Ⓜ MODEL 608C/D VHF SIGNAL GENERATORS

MODIFICATION FOR REGULATED DC FILAMENT OPERATION

S E R V I C E N O T E

hp MANUAL CHANGES

Figure 1. Model 608C/D DC Filament Installation

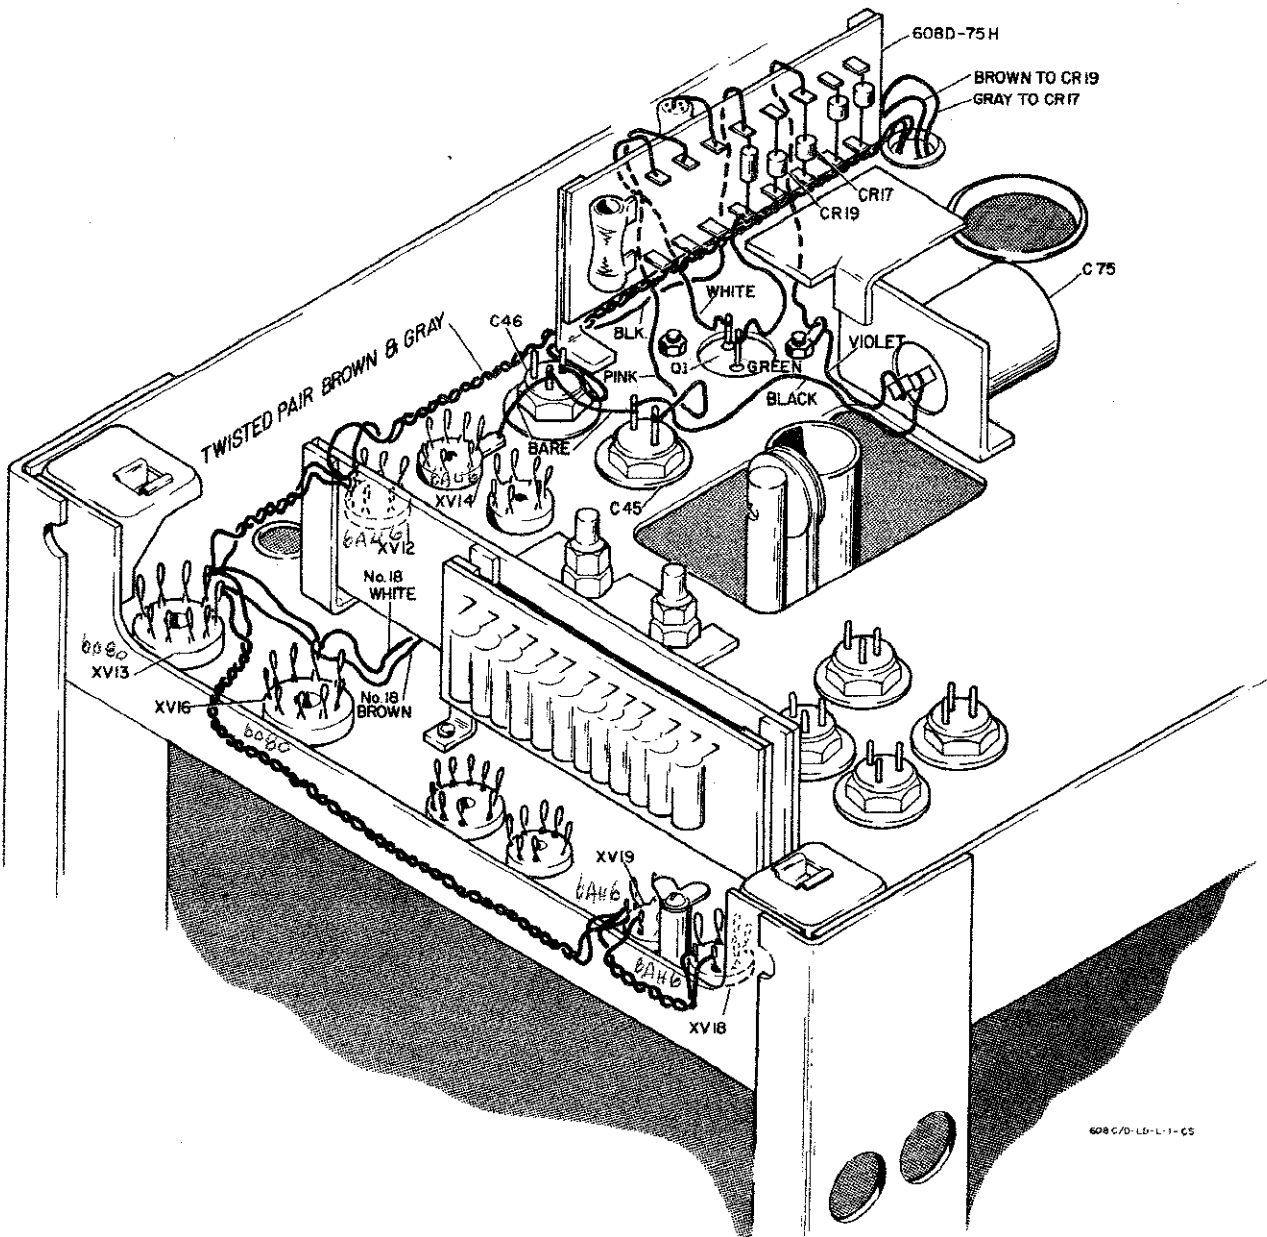
The modification consists of removing the multivibrator supply and installing the regulated DC power supply. The filament windings are then rewired to provide 12.6 VAC isolated from ground for driving the regulated DC filament supply.

Refer to Figures 1 and 2 for the following wiring steps.

7. Mount transistor Q1, 1850-0087, at location of XV17. Slot one hole with a #27 drill to ease mounting of Q1. Make sure collector is not grounded.
8. Mount rectifier board assembly 608D-75H at location of 608D-75C.
9. Mount capacitor C75, 1000 mf, 25 vdc. Do not mount attenuator cable shield at this time.
10. Connect short white wire on 608D-75H to emitter of Q1 (S1).

17. Run brown and gray wire from T1 through 3/4" hole at lower left of T1. Follow black and white wires to opposite side of chassis. Then run the brown and gray wires through the 1/2" hole in the lower right hand corner at the rear of the chassis. Follow cable harness. Run wires under 608D-75H. Connect gray wire to junction of CR-17 and CR-18 (S2). Connect brown wire to junction of CR-19 and CR-16 (S3).

Figure 3. Model 608C/D VHF Signal Generator

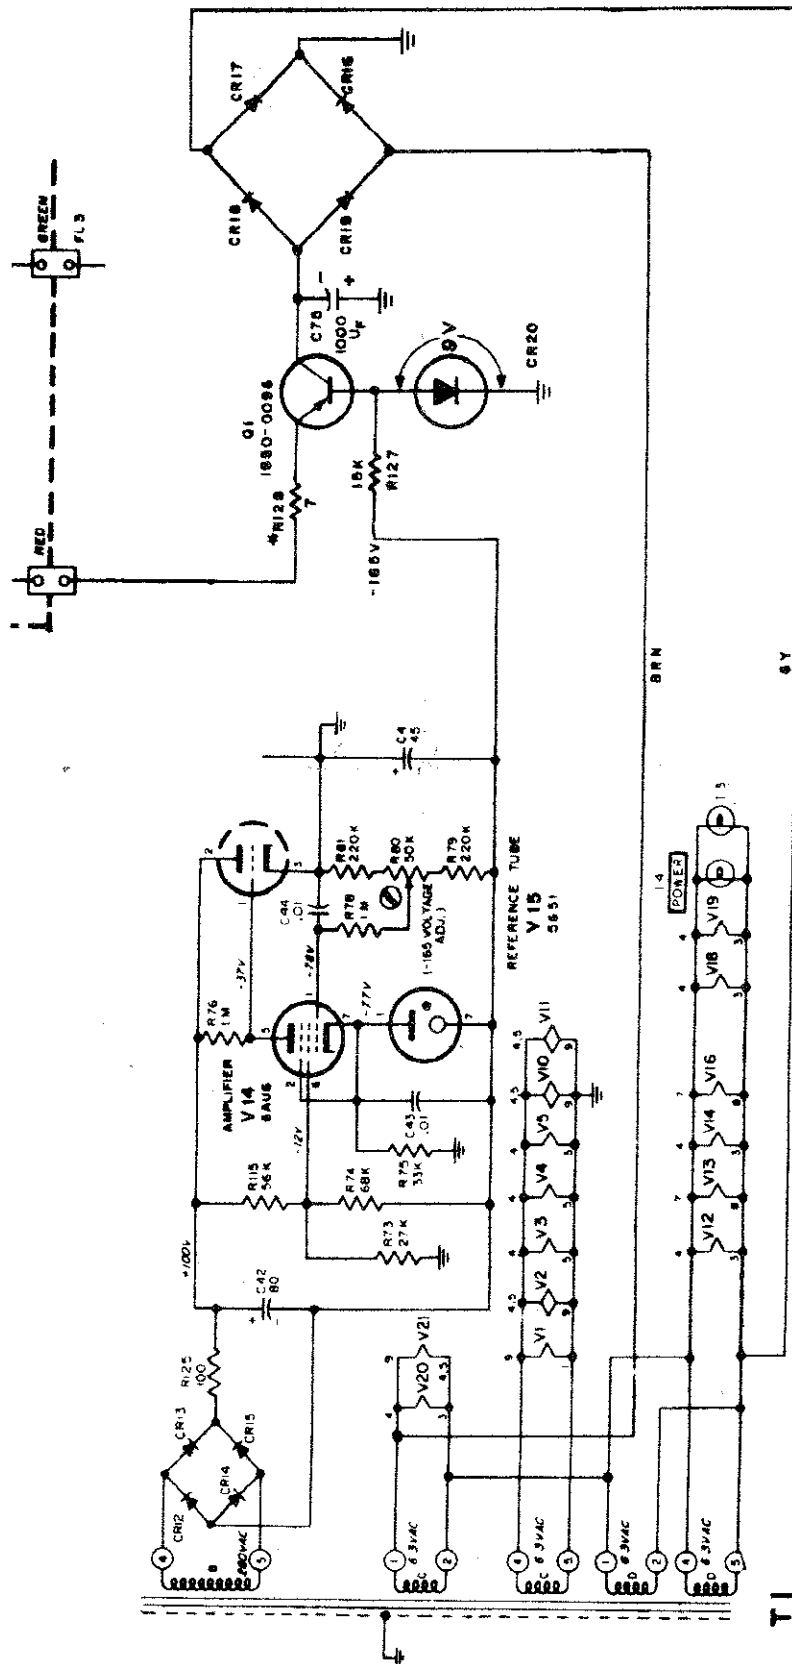
The attached partial schematic, Figure 3, should be added to your Operating and Service Manual for future reference.

CHANGE 1

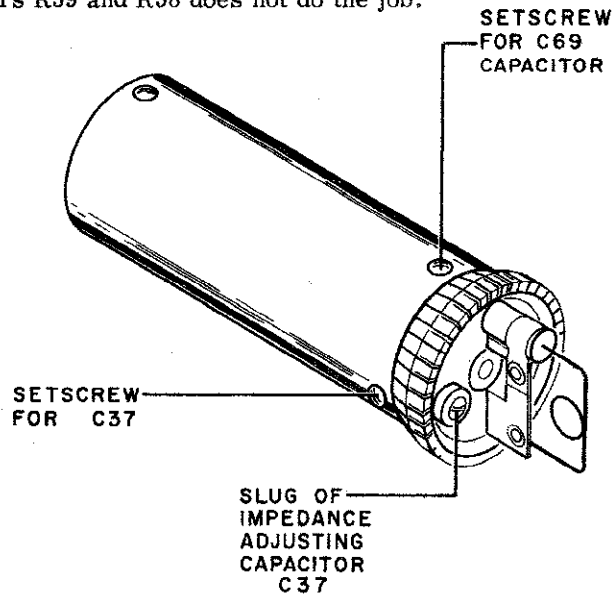
AT1,  Stock No. 608D-34. The attenuator probe assembly shown below is identical to the one shown in Figure 4-8a except that the SETSCREW for C37 is located as shown and may be adjusted for minimum VSWR if positioning resistors R59 and R58 does not do the job.
